<b>TO:</b>	<b>CHAIR AND MEMBERS – PLANNING &amp; ENVIRONMENT COMMITTEE</b>
<b>FROM:</b>	<b>GEORGE KOTSIFAS, P.ENG MANAGING DIRECTOR, DEVELOPMENT &amp; COMPLIANCE SERVICES AND CHIEF BUILDING OFFICIAL</b>
<b>SUBJECT:</b>	<b>APPLICATION BY: HOMES UNLIMITED 770 WHETTER AVENUE/8 FAIRVIEW COURT PUBLIC SITE PLAN MEETING DECEMBER 4, 2017 4:30PM</b>

That on the recommendation of the Manager, Development Planning, the following actions **BE TAKEN** with respect to the Site Plan Control Application relating to the property located at 770 Whetter Avenue/8 Fairview Court:

The purpose of this application is to attain Site Plan Control Approval for an apartment building, four (4) storeys in height with fifty-four (54) residential units at 770 Whetter Ave/8 Fairview Court. The application is to be heard at public meeting of the Planning and Environment Committee. The site contains a holding provision (h-5) to require a public site plan review, a holding provision (h-18) to ensure the lands are assessed for archaeological resources, and a holding provision (h-65) to ensure there are no conflicts between the adjacent arterial roads and/or rail line.

**1: Site Plan Reviewed by Council 2012**

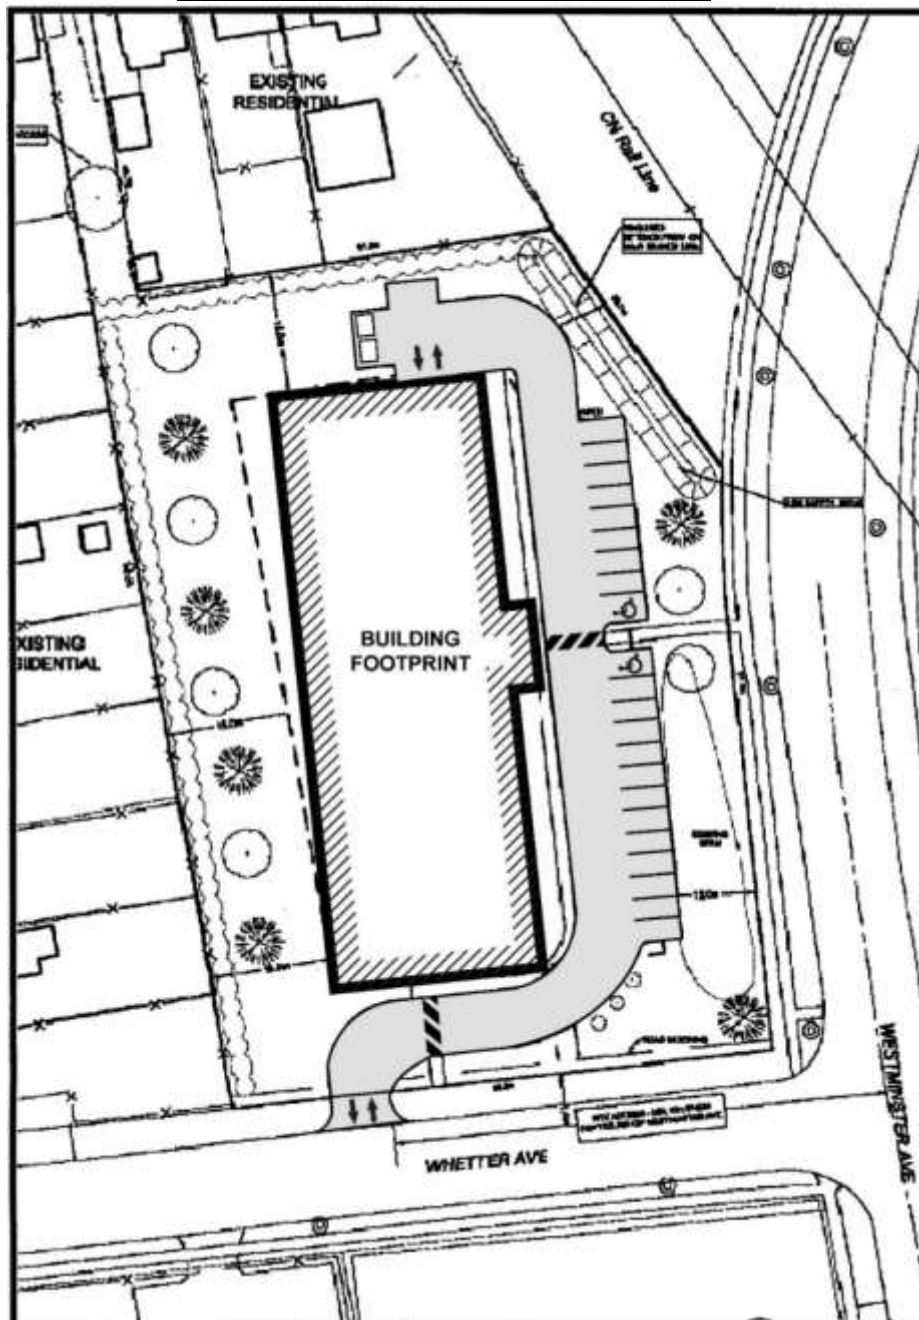
The Site Plan under review differs from what was reviewed by Council in 2012 (refer to **Image 1** below). The proposed changes include the location of the building (previously located more central to the site), the location of the parking (previously located along Westminster Avenue on the east side of the building and underground), and no underground parking spaces are proposed in this application (refer to **Image 2** below). Since 2012, there has been no development on site. The current Site Plan proposal locates the building further way from the existing single family dwellings and has stronger street prominence. The parking is now located behind the building and is well screened with privacy fencing and landscaping. The proposed Site Plan is in conformity with the applicable policies and current Zoning By-law.

- The site plan differs from what was previously reviewed by Council in 2012 when the existing Zoning was adopted; City staff are seeking Council to advise on the changes of building and parking locations, and the lack of forty-seven (47) underground parking spaces, which differs from the 2012 submission.

**Image 2: Site Plan 2017**

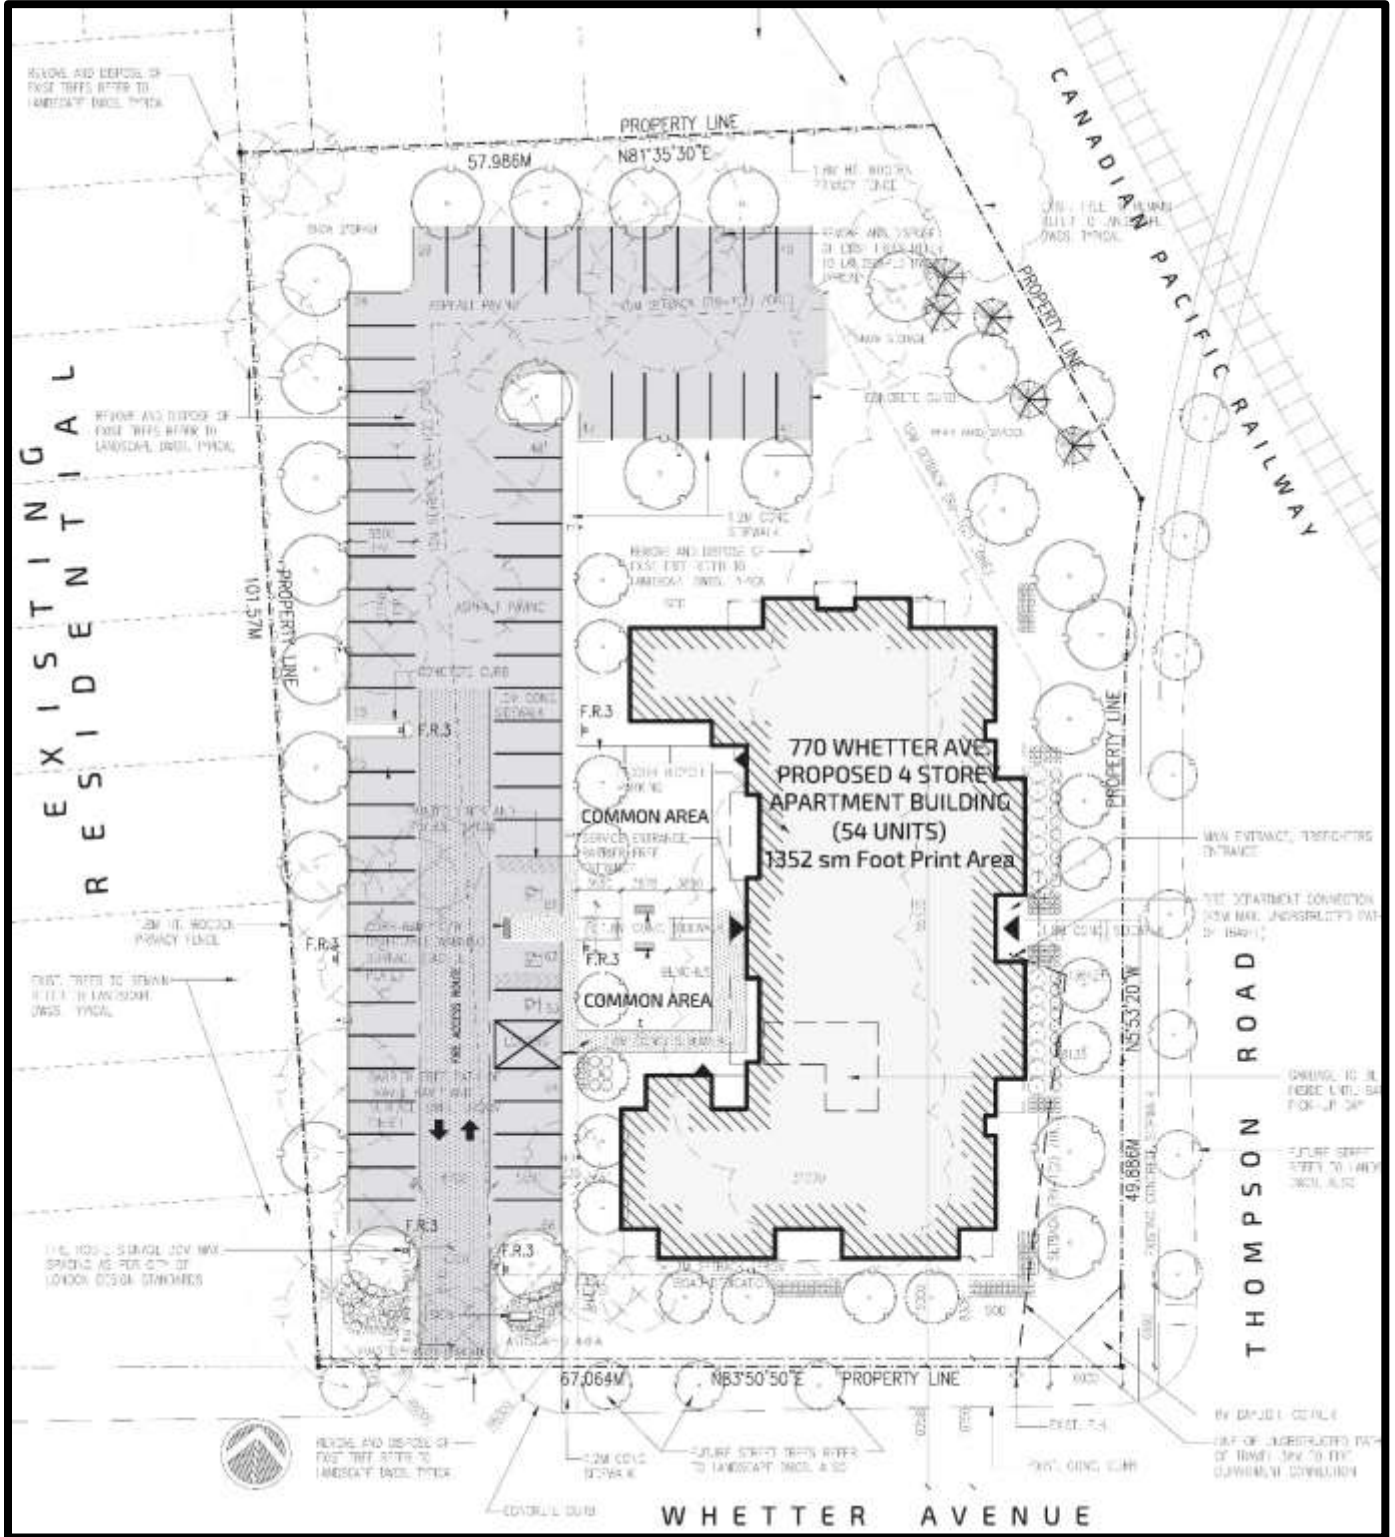
- The traffic management plan is to be updated.
- Concerns of basement flooding is still outstanding. The storm water management report is to be updated to detail drainage patterns for subject site and surrounding lands in existing condition and major storm events. Report requires further revisions (see Appendix ‘B’ for more detail)

- Grading plans are to be revised to ensure positive drainage from external lands is implemented toward the overland flow conveyance swale. Cross sections are to be provided.

- Plans are to conform to the requirements of the CN, including the acceptance of a noise and vibration study, setback from railway of 15 metres, a 1.83 metre chain link fence along the mutual property line, grant CN an environmental easement, and include provisions relating to noise and vibration within the development agreement.
